NINE MILE POINT NUCLEAR STATION, UNIT 2

AMENDMENT TO FACILITY OPERATING LICENSE

Amendment No. 84
License No. NPF-69

ATTACHMENT TO LICENSE AMENDMENT NO. 84

FIGURE 3.4.6.1-1 MINIMUM BELTLINE DOWNCOMER WATER TEMPERATURE FOR PRESSURIZATION DURING HYDROSTATIC TESTING AND SYSTEM LEAKAGE TESTING (REACTOR NOT CRITICAL) FOR UP TO 12.8 EFFECTIVE FULL POWER YEARS OF OPERATION

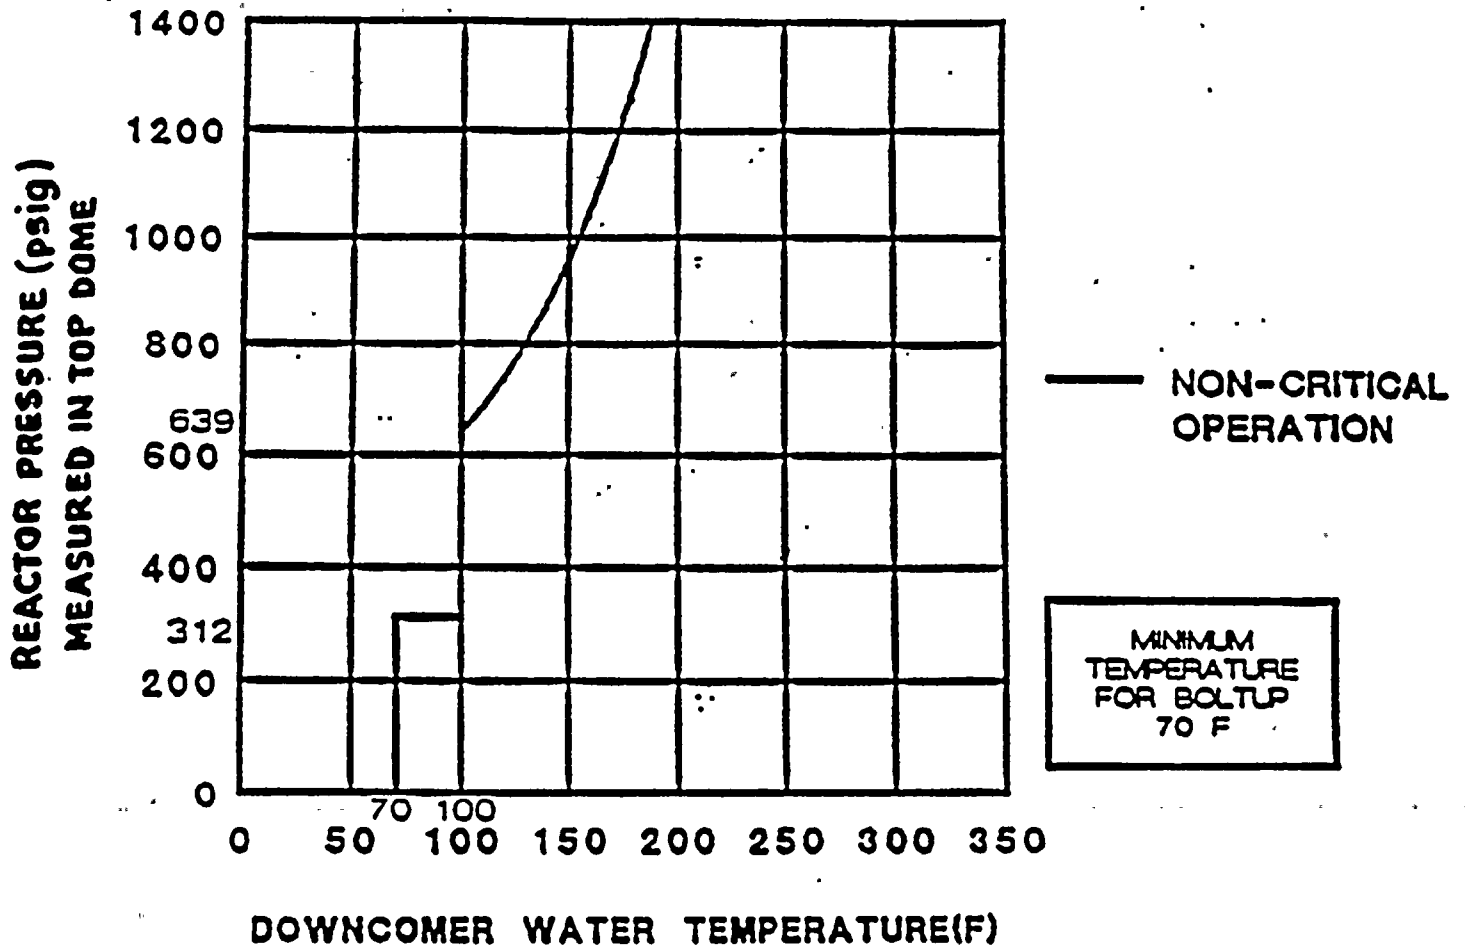
3.4.6.1 The reactor coolant system temperature and pressure shall be limited in accordance with the limit lines shown on Figure 3.4.6.1-1 for hydrostatic or system leakage testing. Figure 3.4.6.1-2 for heatup by non-nuclear means. Figure 3.4.6.1-3 for cooldown following a nuclear shutdown and low-power PHYSICS TESTS; and Figures 3.4.6.1-4 and 3.4.6.1-5 for operations with a critical core other than low-power PHYSICS TESTS, with:

4.4.6.1.1 During system heatup, cooldown, and system leakage and hydrostatic testing operations, the reactor coolant system temperature and pressure shall be determined to be within the above required heatup and cooldown limits and to the right of the limit lines of Figures 3.4.6.1-1, 3.4.6.1-2, 3.4.6.1-3, 3.4.6.1-4, and 3.4.6.1-5 as applicable, at least once per 30 minutes.
